Entergy Nuclear Operations, Inc.
Pilgrim Nuclear Power Station
600 Rocky Hill Road
Plymouth, MA 02360

Additional Information Concerning Revised Request for Authorization
under the Provision of 10 CFR 50.55a(a)(3)(i) for Modification of Core
Shroud Stabilizer Assemblies (TAC NO. MD4918)

LETTER NUMBER: 2.07.045

Additional Information In Support of Proposed Core Shroud Stabilizer Assembly Configuration

Figure 1

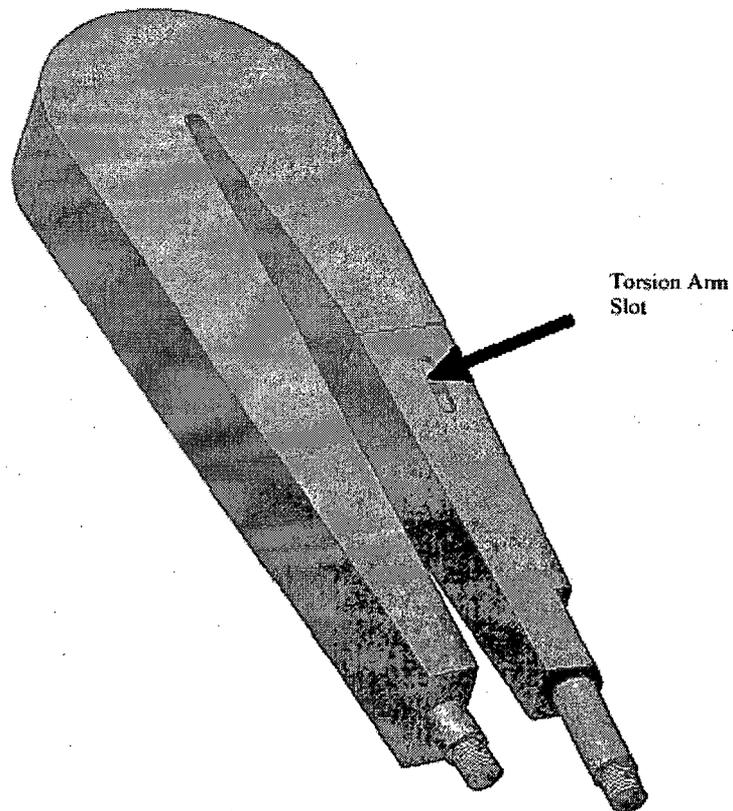
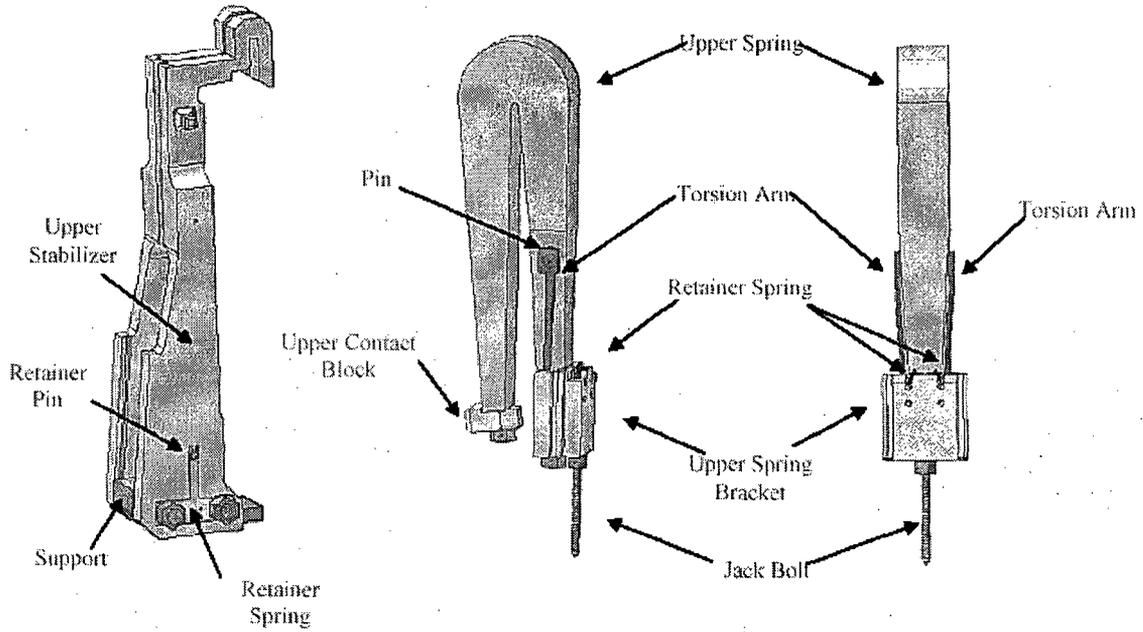
RAI 2a

What is the maximum rotation considering the design and failure of the torsion arm bolt?

The torsion arm assembly and torsion arm clamp are shown in Figures 1, 2, 3, and 4.

The nominal rotation is 4.2°. Considering the tolerances, the maximum rotation is 5° in each direction
